P 535982

## ON-SITE SEWAGE DISPOSAL SYSTEM TANK REPLACEMENT HOWARD COUNTY HEALTH DEPARTMENT BUREAU OF ENVIRONMENTAL HEALTH

ADDRESS: 14093 Monticello Drive PROPERTY OWNER: Christopher Lore

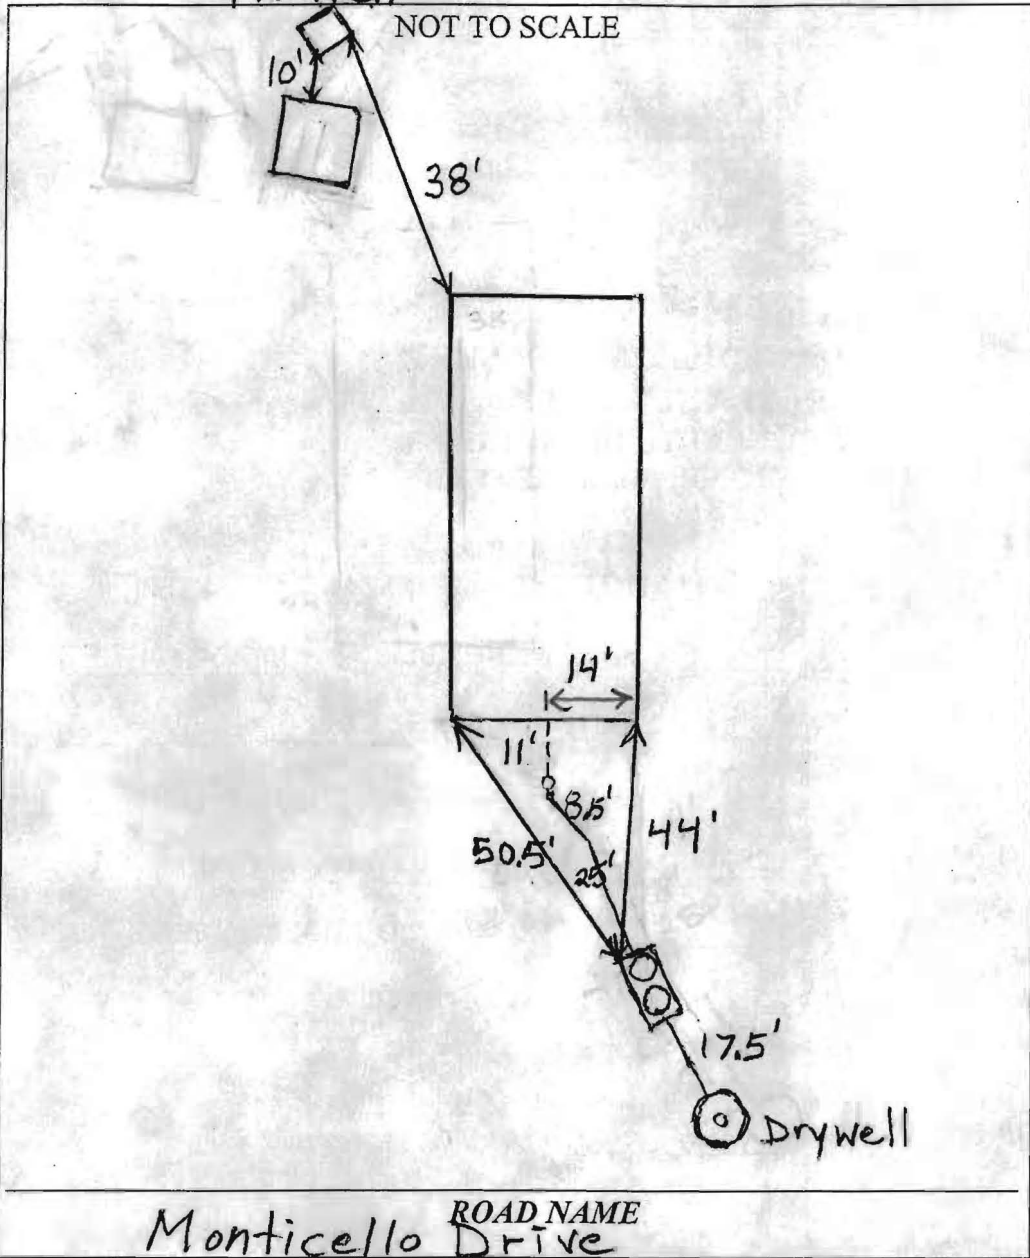
9/21/2011 O.K. to install tank further downhill from existing tank. Keep depth to no more than 3.5'. Existing tank pumped and abandoned. Fill drywell with gravel. (BB)

9/21/2011 P.M. New tank installed. Connection made to house. Drywell cover removed. Drywell empty. (BB)

9/22/2011 Called contractor to confirm that drywell was filled. A piece of perforated pipe was put in the drywell. (BB)
